STRUCTURAL ADDENDUM-No: SA-01

Re: 321 John Street, Cobourg, ON
Clarifications & Updates to Structural Documents

The following items are changes to project Contract Structural Documents. General Contractors shall include the items described in their tender bid including all labour, material, equipment and services required to complete the work described.

S503

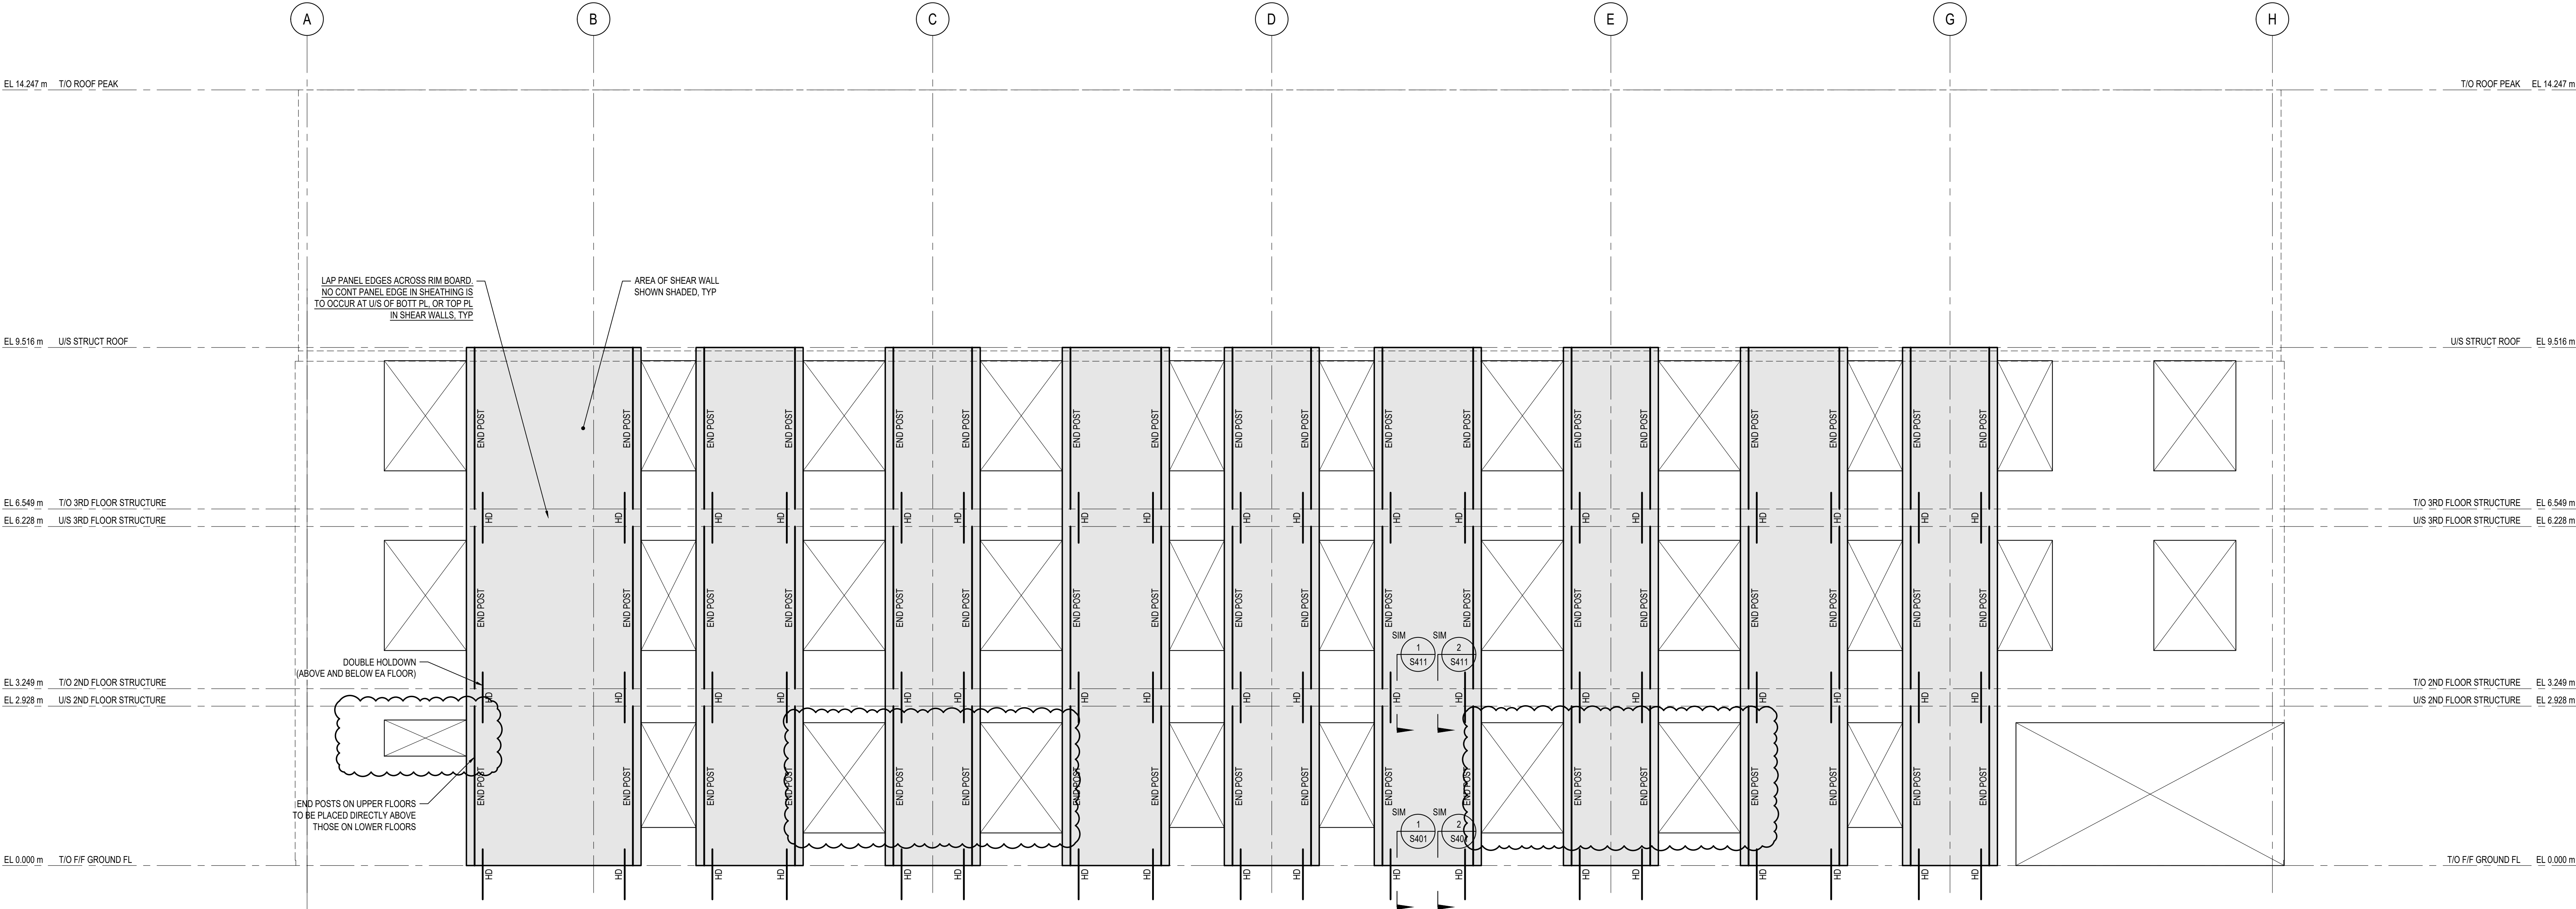
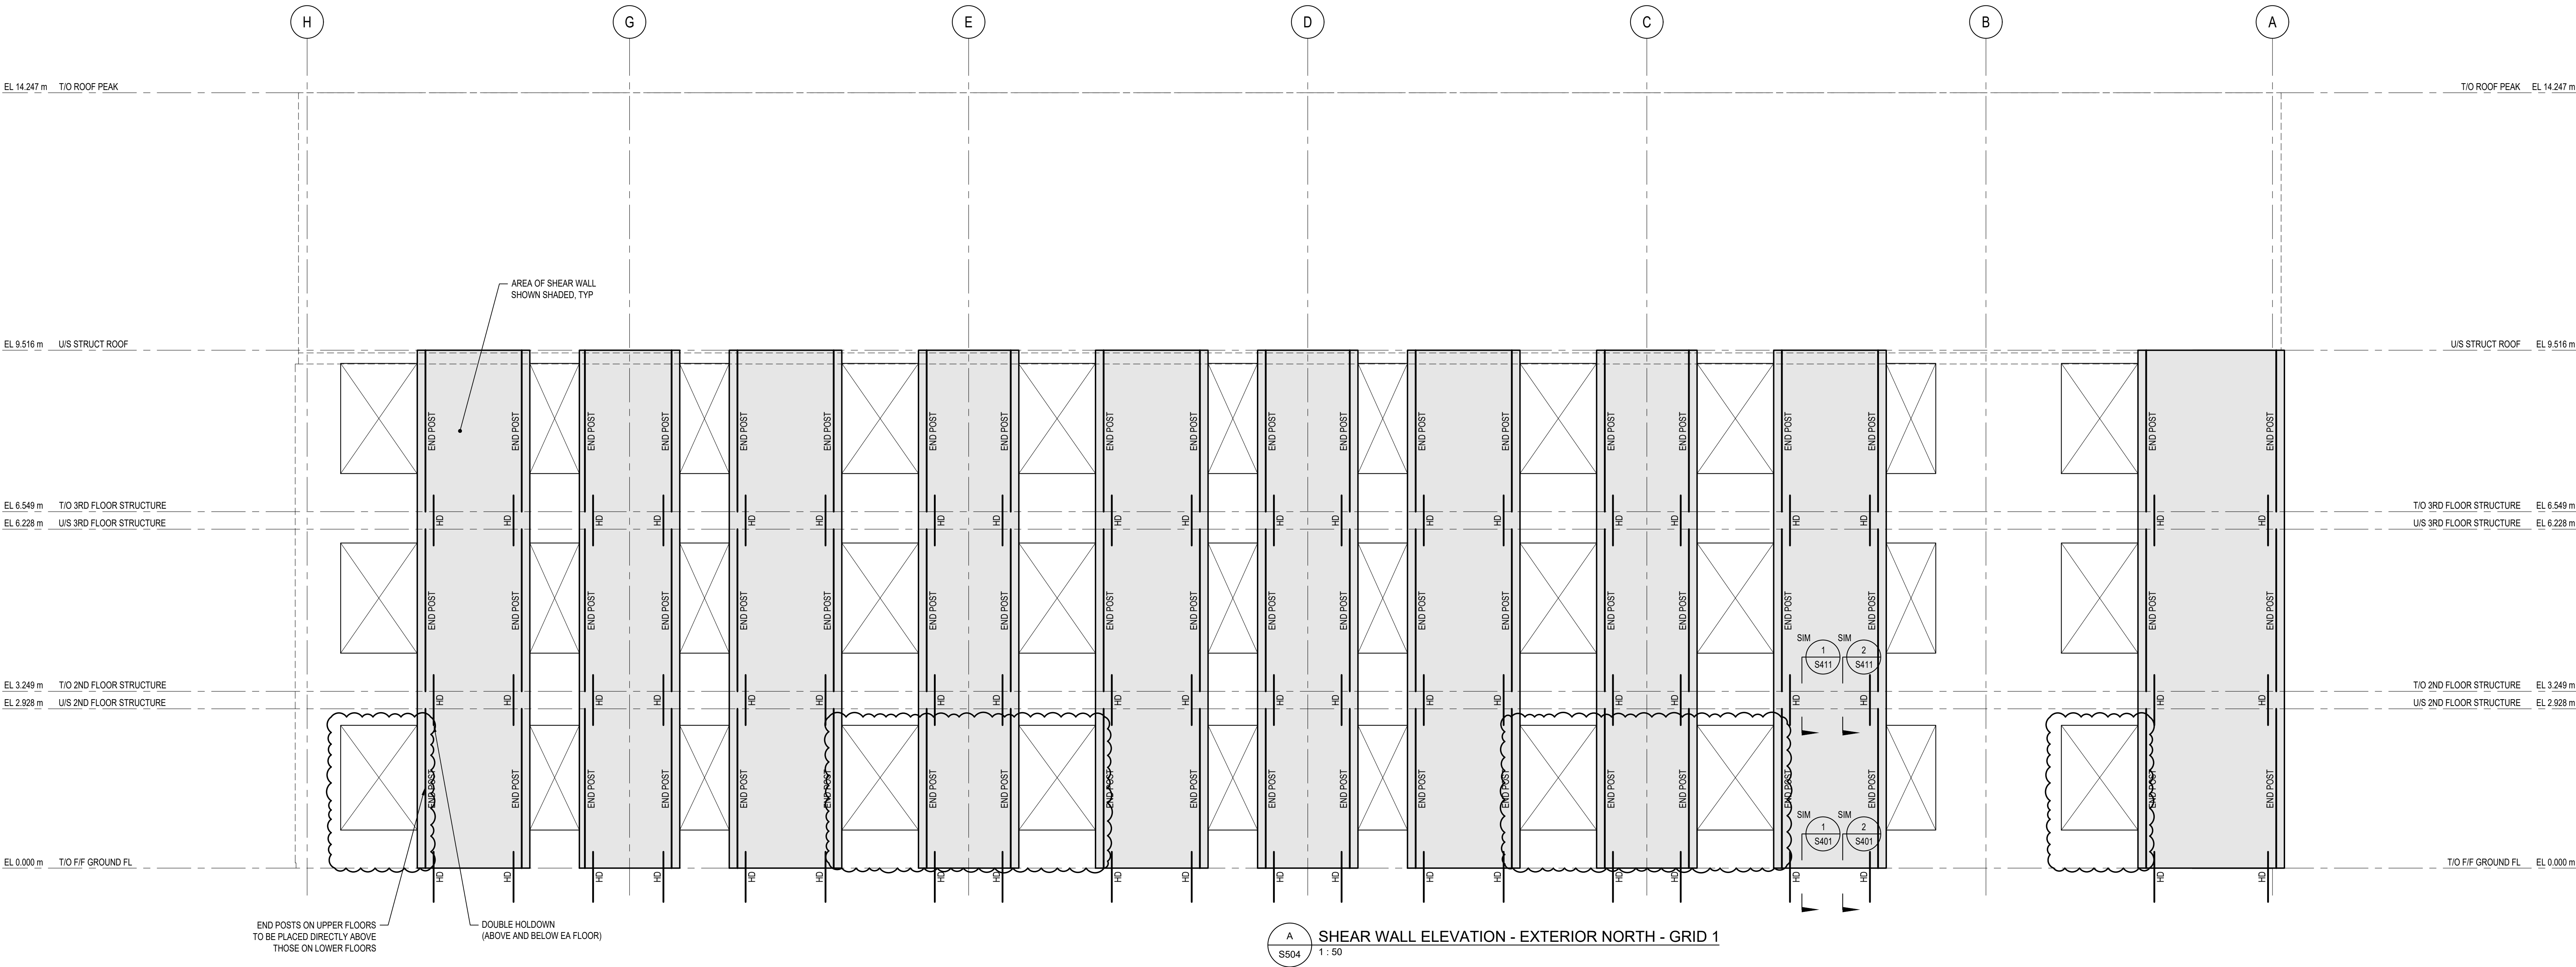
14.0 S503 Shear Wall Elevations

14.1 Visual adjustment made to openings by request from architect.
